Access Compliance Report

Public Rights-of-Way

Intersection ID: 48058	Main Street: FERRELL_AV	Cross Street: KEENER_RIDGE_RD	Location: NW
ADA ID: BB9A165033A1	Ramp Type: Perp	Initial Pass/Fail: Pass	Overall Compliance: No
		Severity Score: 5.25

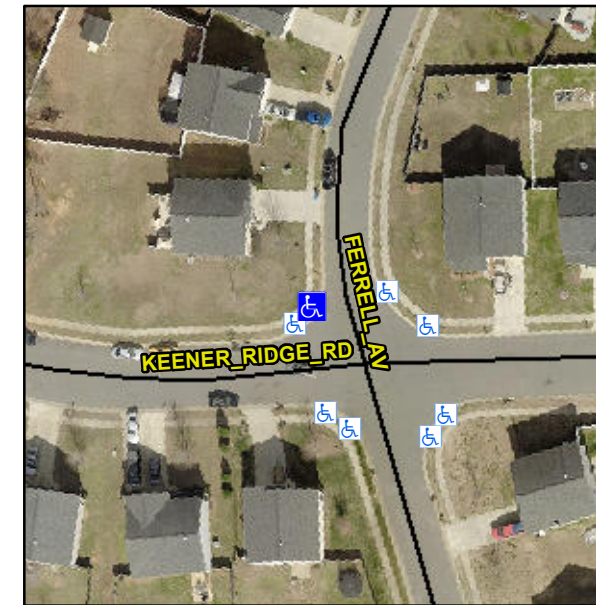
**Not Found, R304.5.3, R304.2.1,
R304.2.2-Perp, R304.3.2-Para,
R304.5.4**

Possible Solutions:

**Remove & Replace Entire Ramp.
Remove & Replace Gutter.**
